REPORT OF THE
INDEPENDENT TECHNICAL
REVIEW
COMMITTEE EVALUATION
OF THE MOS-1 PORTION OF THE LOS ANGELES
METRO RAIL PROJECT

January 3, 1985⁶

BORINGS AND FAULTS
FIGURE 1

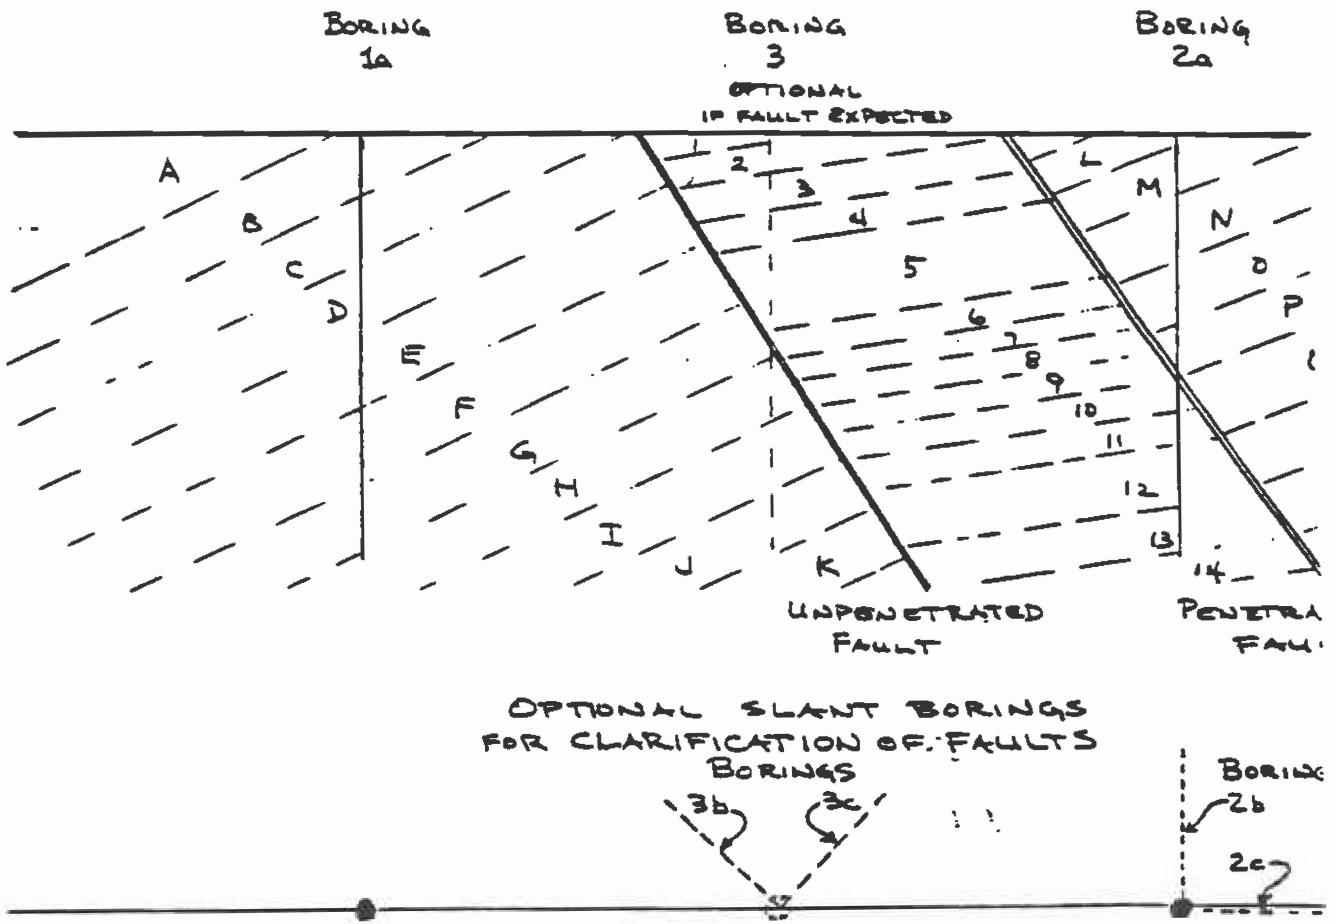
2. QUESTION BY J. SLOSSON:

3. QUESTION BY UNKNOWN MEMBER OF COMMITTEE:

How do you decide what part of tunnel gets the steel liner?

In those instances where it is not practical to map geology inside the tunnel, cored holes could be used in advance of tunneling as shown in Figure 1 to pinpoint discontinuities.

Fabricated steel linings have been recommended for use in sections of tunnel meeting any one of the following three criteria:

- a. Fault Zones - Fabricated steel linings are recommended for use where the tunnel crosses potentially active fault(s) as defined by Converse Consultants, Inc., and Lindvall Richter and Associates.

FIGURE 2

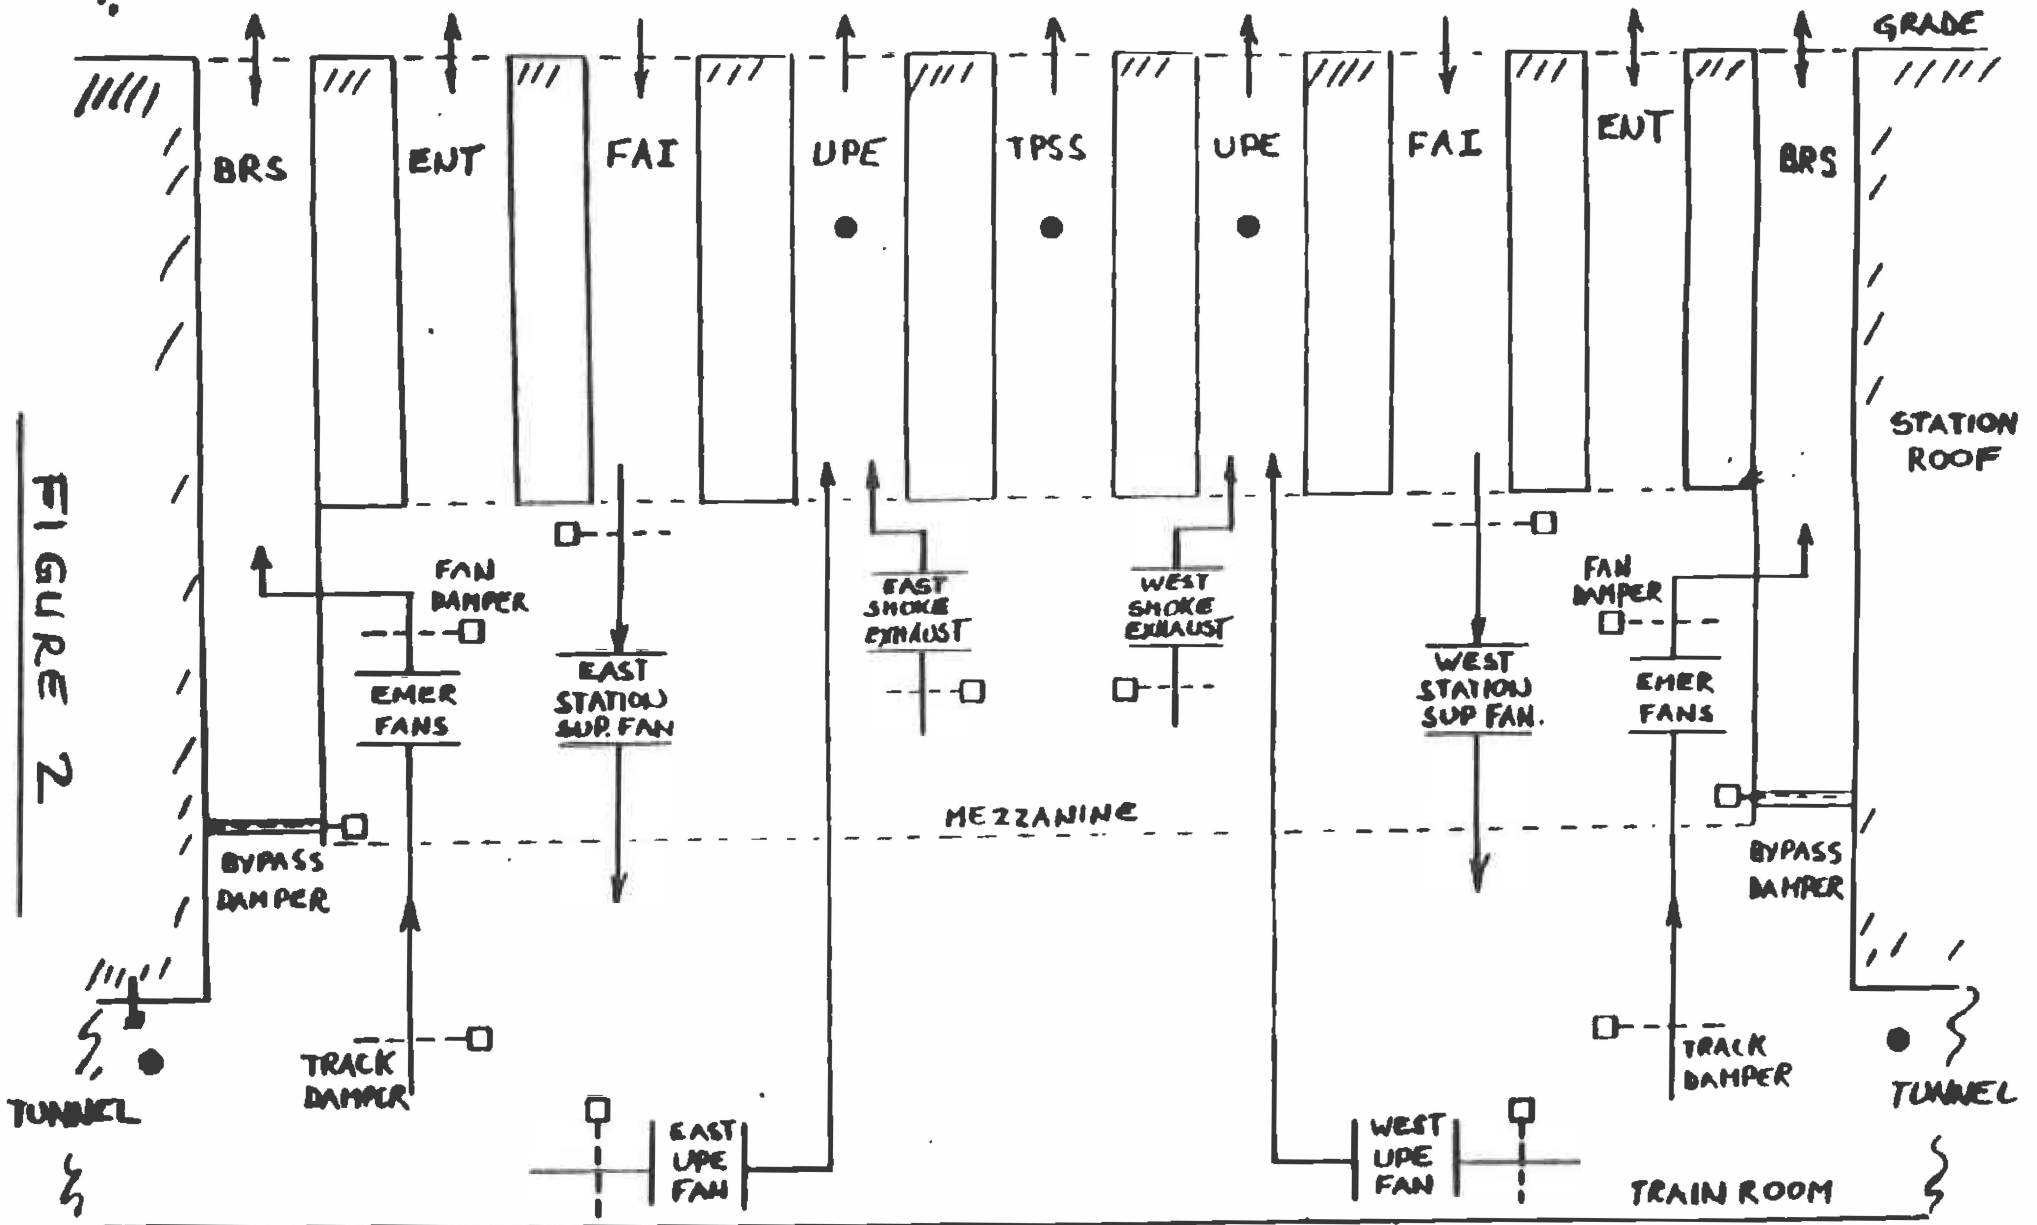
PART (B) The discussion before the Committee left some unresolved questions concerning the gas detection system, how employees will be alerted to changes in gas concentrations and what will occur automatically vs. that which will occur as the result of human intervention. Please give a brief description of the proposed system to sense for the presence of gas, location of gas monitors and

PART (C) Please clarify the alerts to be given control room operators - clearly specify if multiple warnings or alerts will be sounded and describe the concentration levels of gas that will trigger the "low", "moderate" and "high" or other "warnings" or "alerts".

Actions to be taken in the event of alarm level gas concentrations are displayed to the central control operator from the Metro Rail computer. The operator will review the proposed actions and initiate them by acknowledging to the computer that he is in agreement. The computer will then control the specific operations, i.e., starting fans, closing dampers, etc. If the central control operator does not agree with the proposed actions, he can modify those actions. Before the alarm level gas concentration is reached, plans include utilizing portable gas detection units to survey

and locate the specific area/point of infiltration so that corrective measures can be taken. If conditions warrant, system evacuation or other emergency measures will be implemented.
